MOOG
STEERING & SUSPENSION

DID YOU KNOW?

Overview

Inspection Procedure for affected Dodge Ram 4x4 vehicles

Photo 1

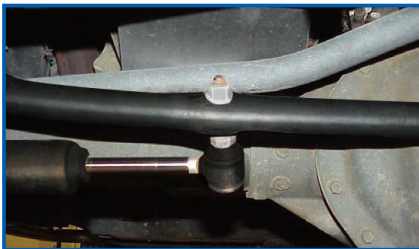
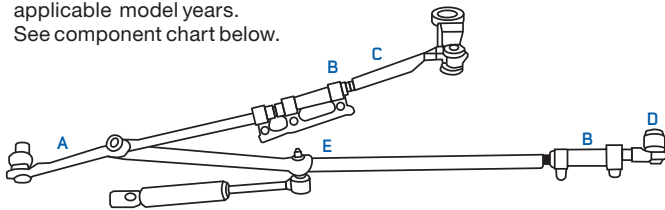
Examine the steering damper attachment point as follows:
If the steering damper is bolted through a tapered hole in the RH inner connecting tie rod, as originally equipped (Photo 1), the parts have not been altered. It is acceptable to install parts designed for the applicable model years.
See component chart below.

2003-2008 Dodge Ram 2500/3500 4x4, 2006 - mid-year 2008 Dodge Ram 1500 Extnd Cab 4x4 (1st design)			
PITMAN ARM TO RH STEERING ARM	A	RH OUTER TIE ROD END	DS1463
	B	ADJUSTING SLEEVE	ES3626S
	C	LH INNER TIE ROD AT PITMAN ARM	ES3624
LH STEERING ARM TO CONNECTING TIE ROD	D	LH OUTER TIE ROD	ES3625
	B	ADJUSTING SLEEVE	ES3626S
	E	RH INNER CONNECTING TIE ROD	DS1464
